Addendum No: One (01)

Project: Sedalia Downtown Streetscape Phase IV

Project No. 2019-03

Date: June 27, 2019

SHEET NO: C-001

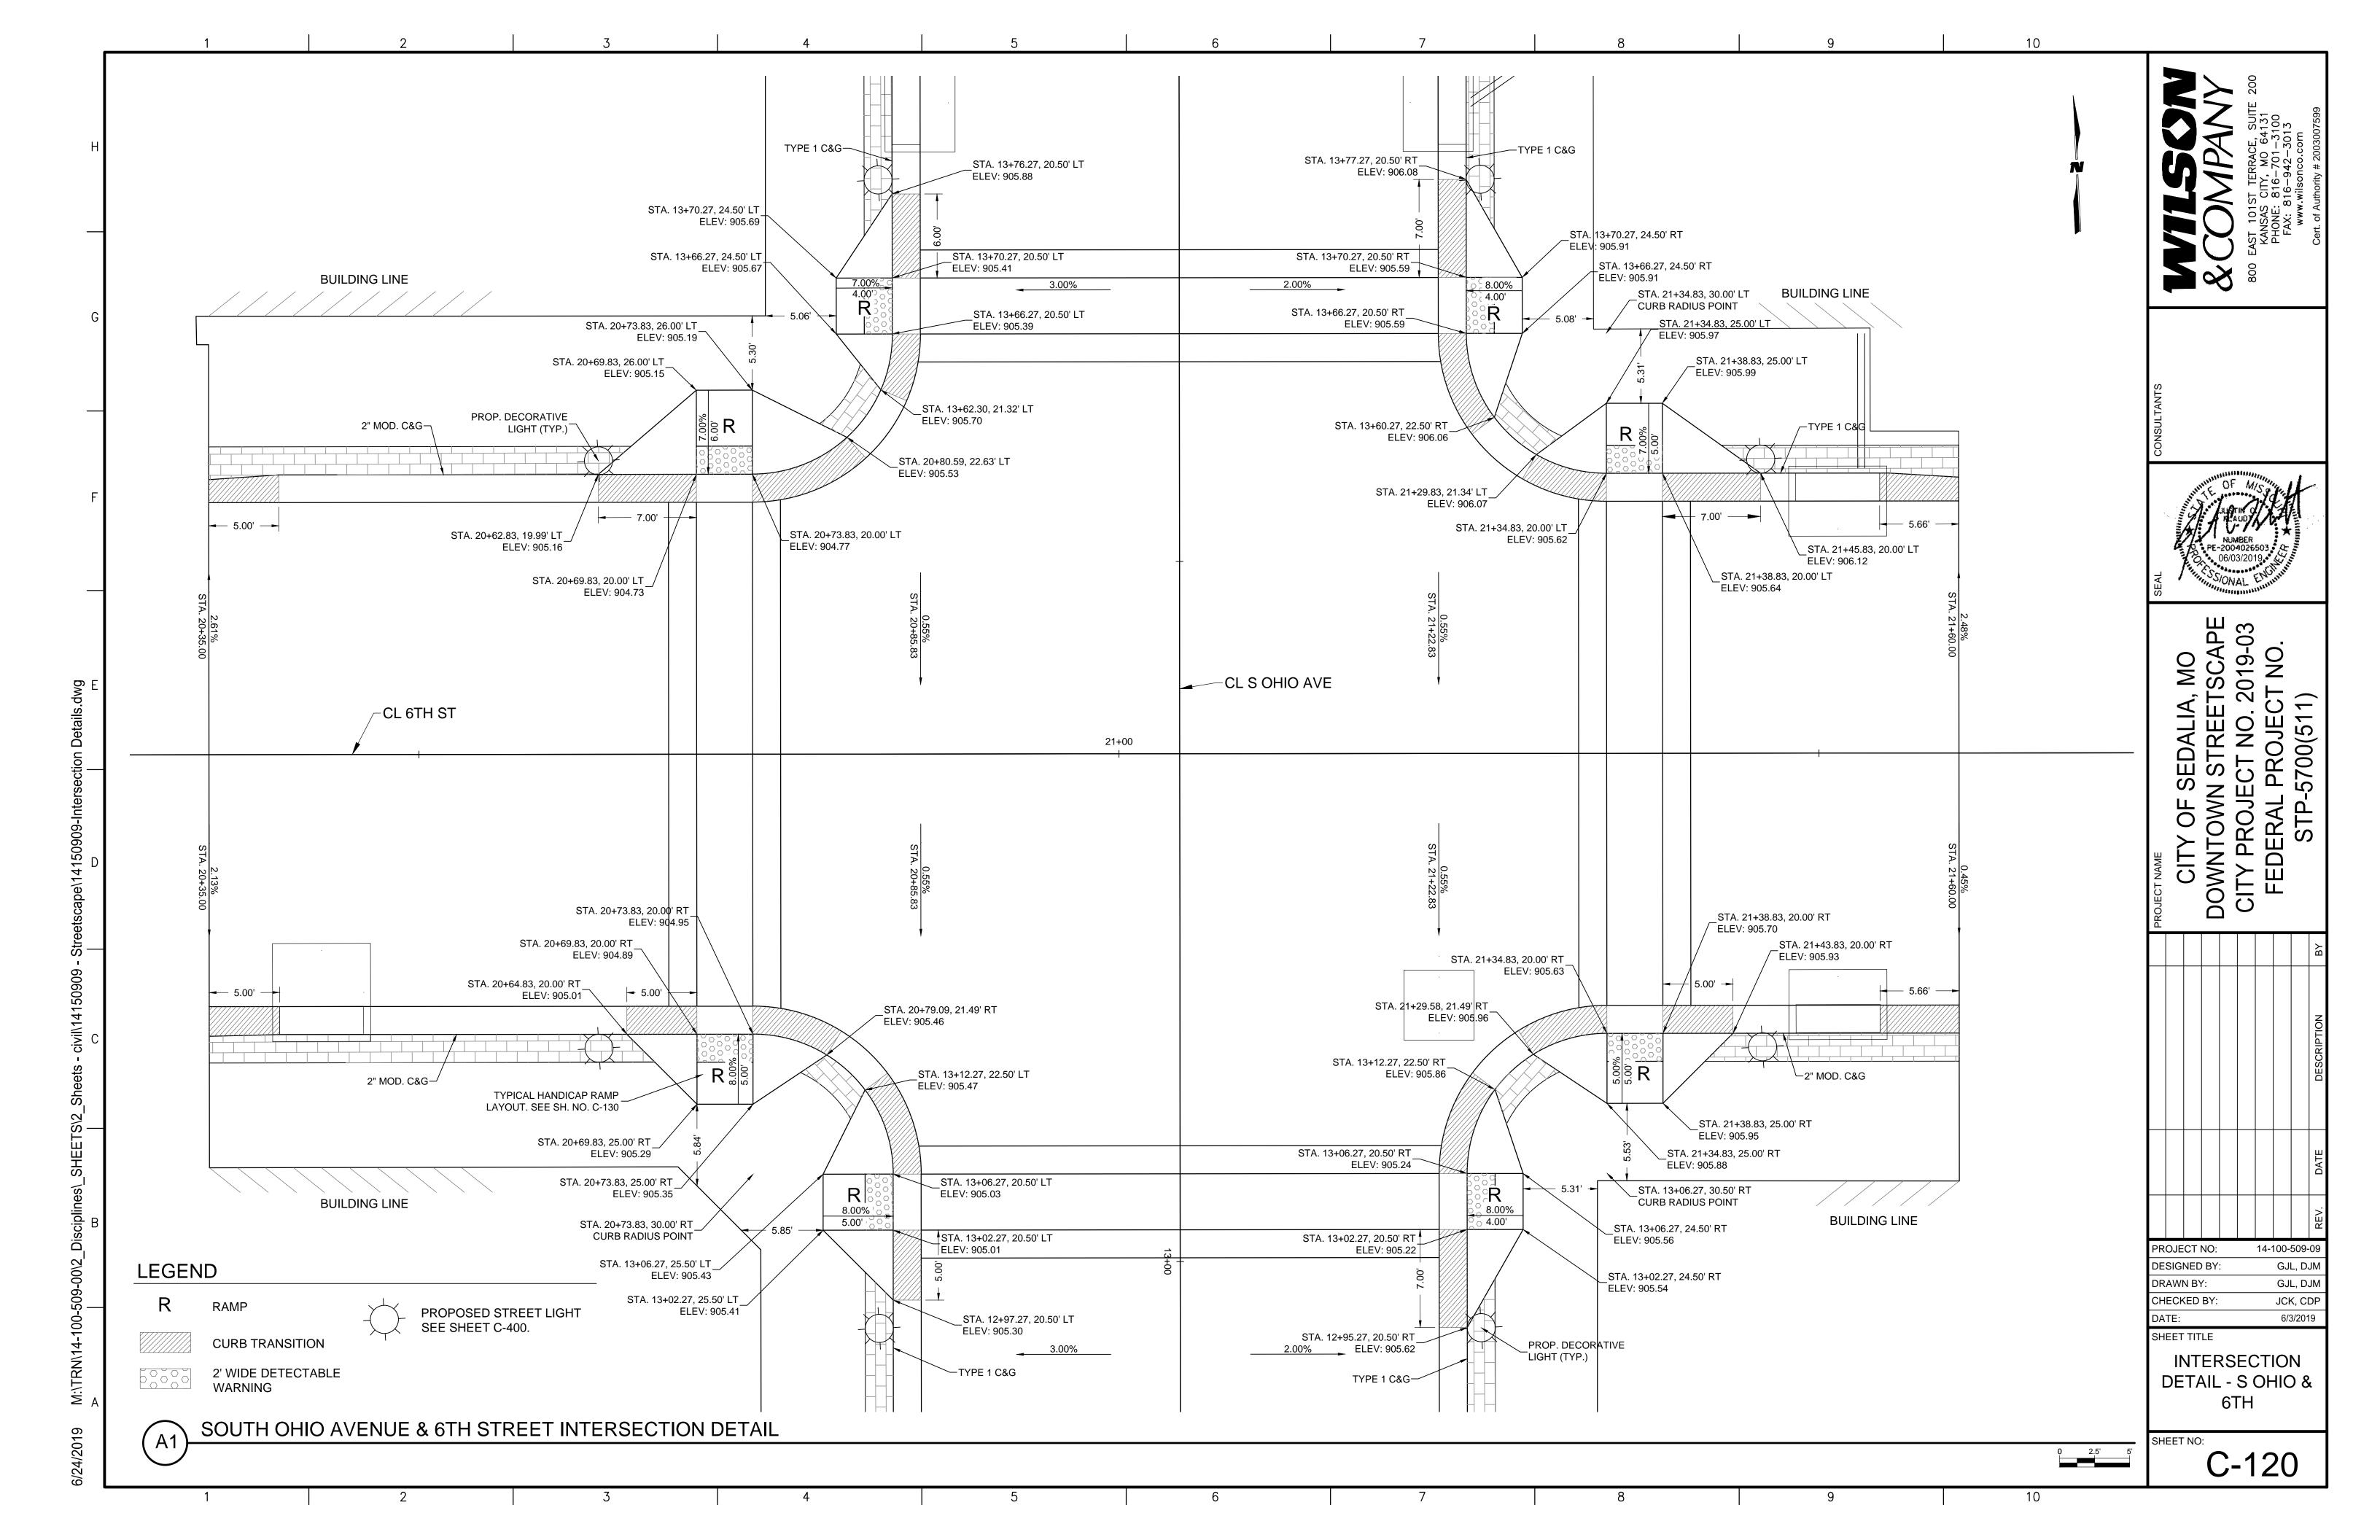
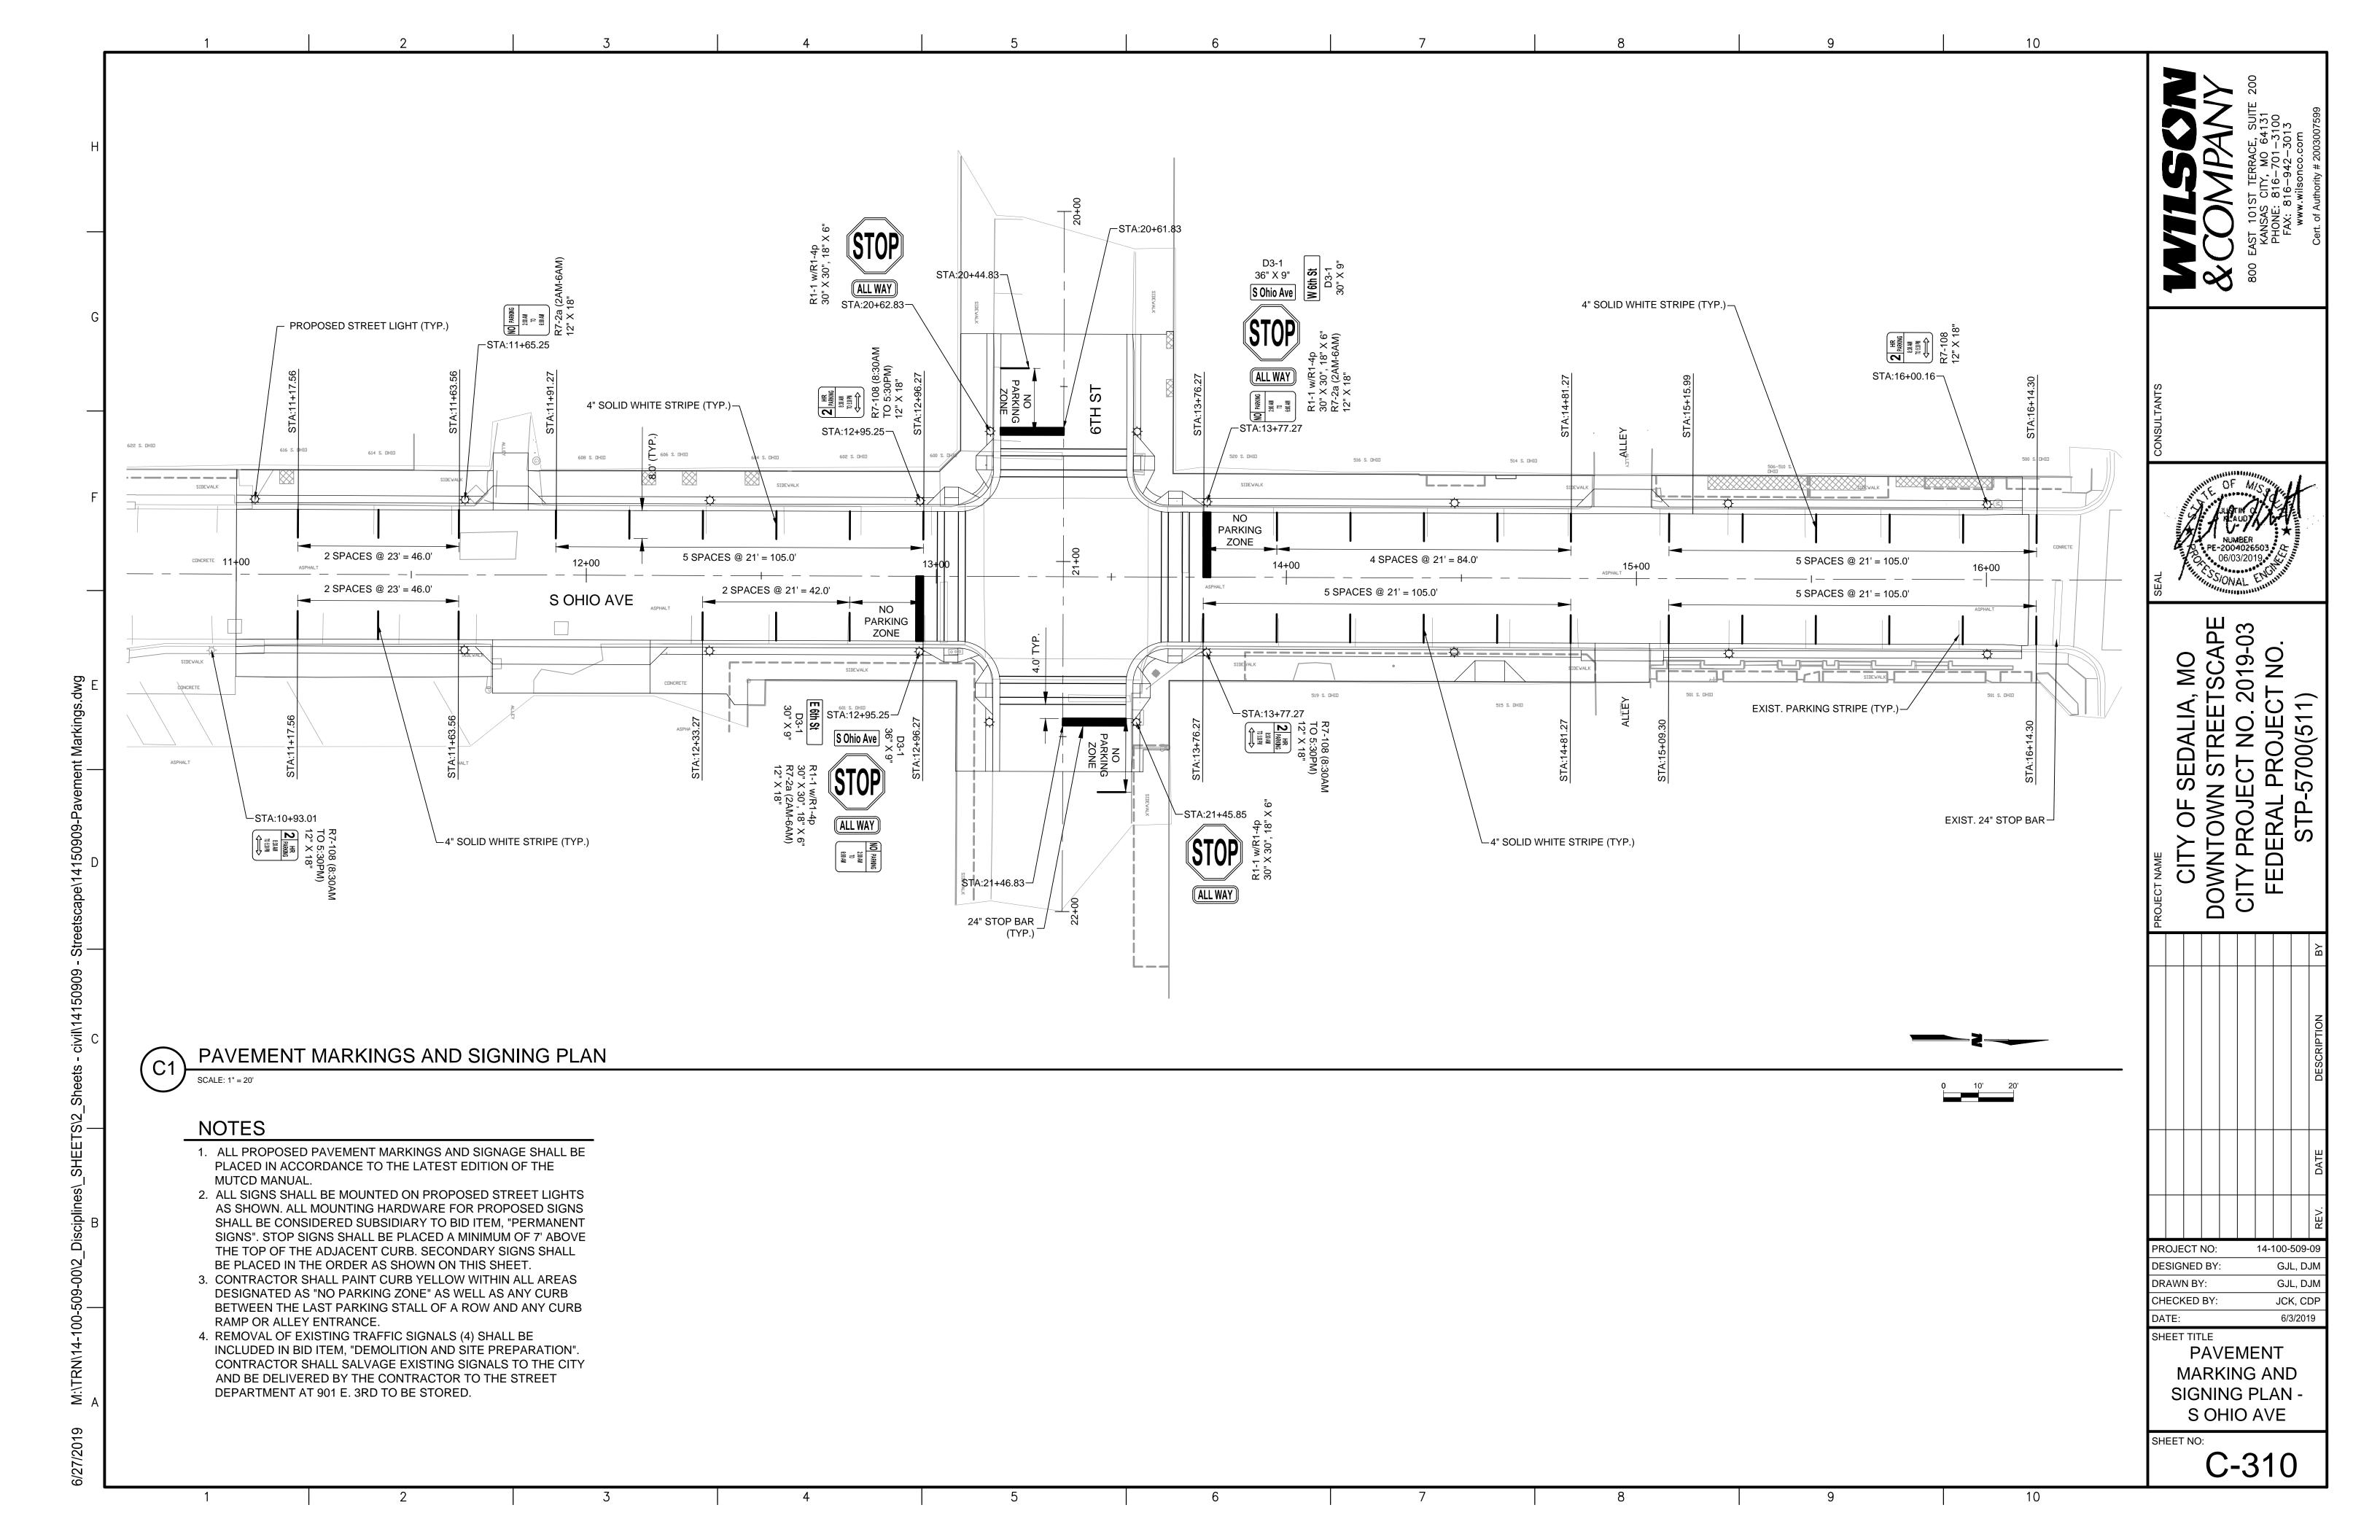
- a. C-000 TITLE SHEET
 - i. Removed Traffic Signal Sheets from Index of Sheets.
 - b. C-001 GENERAL NOTES & SUMMARY OF QUANTITIES
 - i. Removed Traffic Signal Bid Item and Decorative Metered Service Pedestal from Summary of Quantities and added Bid Item "No Parking Zone Line".
